Staff Report

Subject: 487 Brightspur Lane

Request for a fence in the front yard of a corner lot on the southeast corner of Brightspur Lane and Brass Lamp Drive. The petitioner is requesting approval for the replacement of a fence on the property, extending from the side of the house, into the “secondary” front yard, along Brass Lamp Drive terminating approximately three feet (3’) from the right of way line.

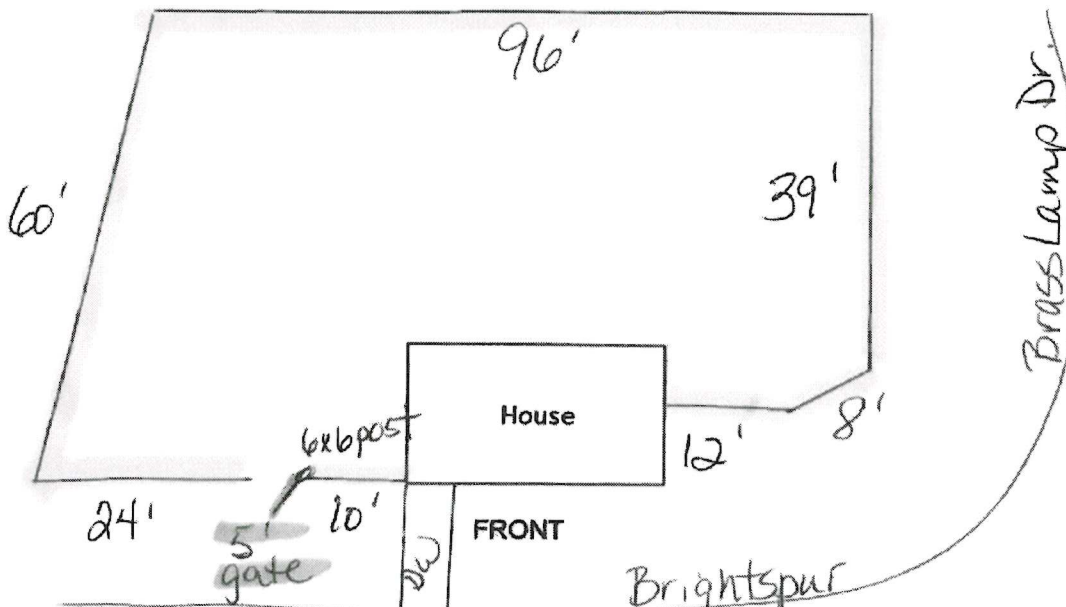
Tear out and remove wood fence and gate
Install 249' Eastern Cedar, Forest park, 1x6DE picket, 1" gap, flat post
Install one 5' wide gate with 6x6 hinge post
